EXISTING LICENSE CONDITIONS AND TECHNICAL SPECIFICATIONS

DESCRIPTION AND SIGNIFICANT HAZARDS CONSIDERATION ANALYSIS  
OF PROPOSED CHANGE NO. 233  
TO PROVISIONAL OPERATING LICENSE NO. DPR-13

This is a request for NRC approval to change Technical Specification Nos. 3.5.1, 3.7.1, 4.1.1, and 4.4 and to add License Condition 3.N for San Onofre Nuclear Generating Station, Unit 1 (SONGS 1). The Technical Specification changes are necessary to reflect modifications of the Safeguards Load Sequencing System (SLSS) that are being implemented during the current refueling outage in accordance with 10 CFR 50.59. The modifications are being performed to satisfy single failure requirements and consist of changes to the SLSS actuation logic. The modified SLSS will enable each sequencer to start and load its associated diesel generator upon a safety injection signal (SIS) and concurrent loss of its respective 4160 volt electrical bus rather than upon a SIS and loss of both 4160 volt buses.

Electrical Distribution System

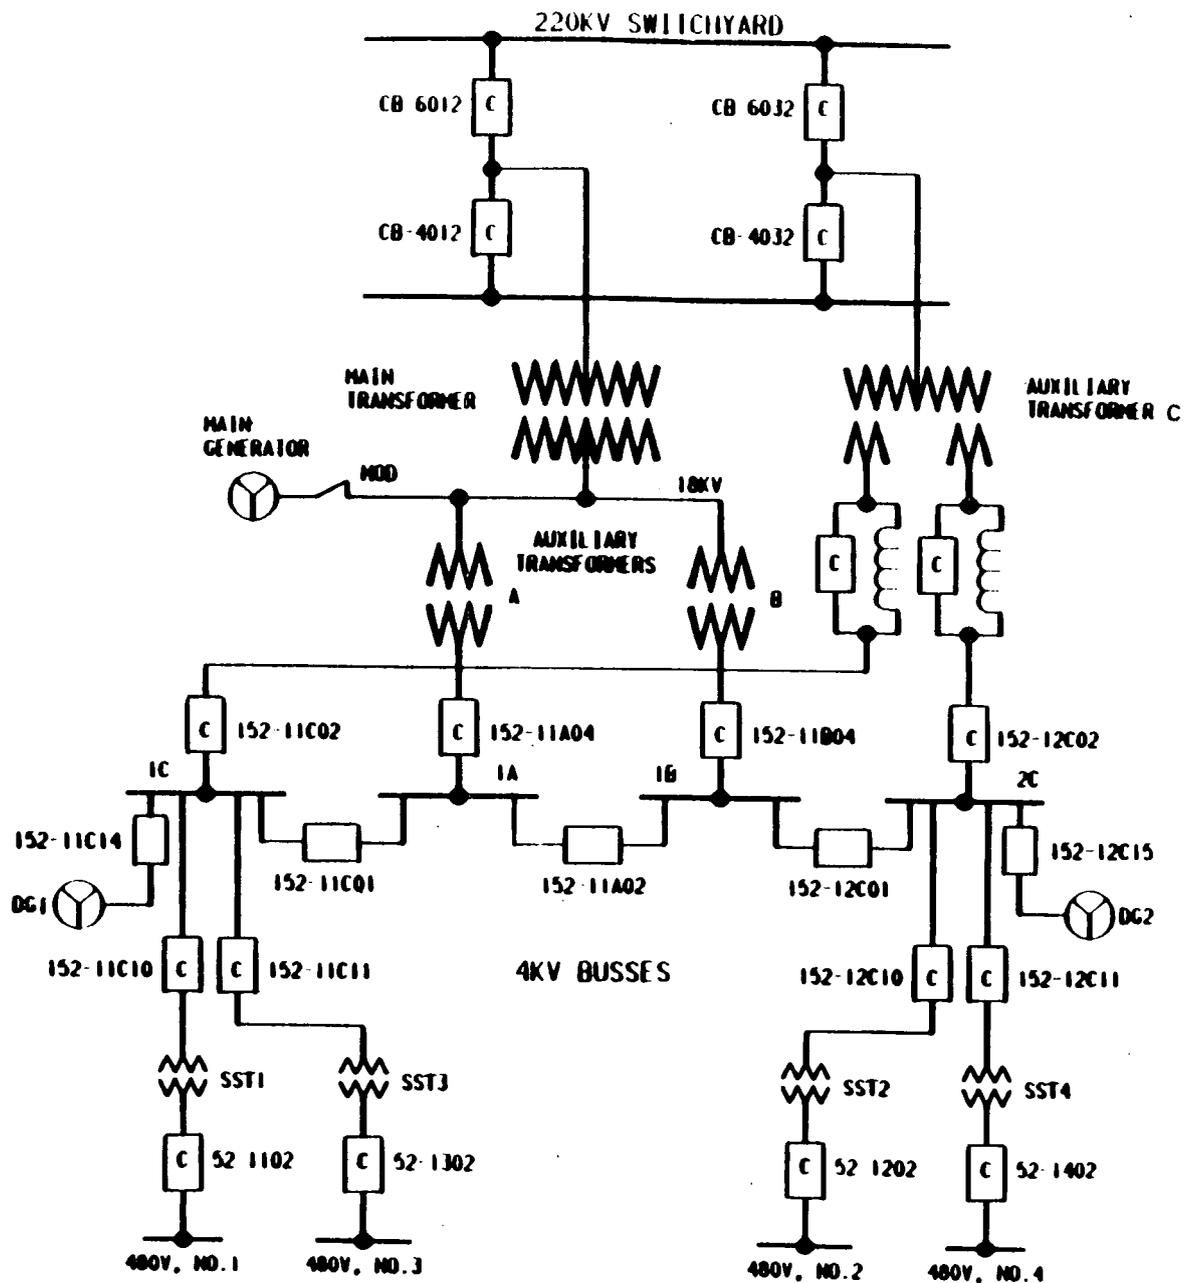
- Modification of the circuitry for each SLSS sequencer to actuate a loss of power signal upon loss of voltage on their respective 4160 volt buses rather than on the loss of both buses.
- Addition of separate actuation logic for initiation of reactor trip upon loss of both 4160 volt buses (to avoid reactor trip upon loss of single bus that would result from modification of the sequencer circuits).

License Condition 3.N is being proposed to schedule installation of a plant modification to resolve a single failure susceptibility affecting the power sources for the vital electrical buses. The plant modification will be completed prior to restart from the Cycle 12 refueling outage. The plant change is necessary to assure that the vital buses are capable of accommodating all safety-related electrical loads so that the plant can reach safe shutdown under all accident conditions.

Southern California Edison Company shall modify the electrical distribution system to ensure that the availability of a power source for vital buses 1, 2, 3, and 3A is not subject to a single failure susceptibility. The plant modification shall satisfy the design requirements of the safety-related portions of the existing electrical distribution system and shall be operable prior to restart from the Cycle 12 refueling outage.
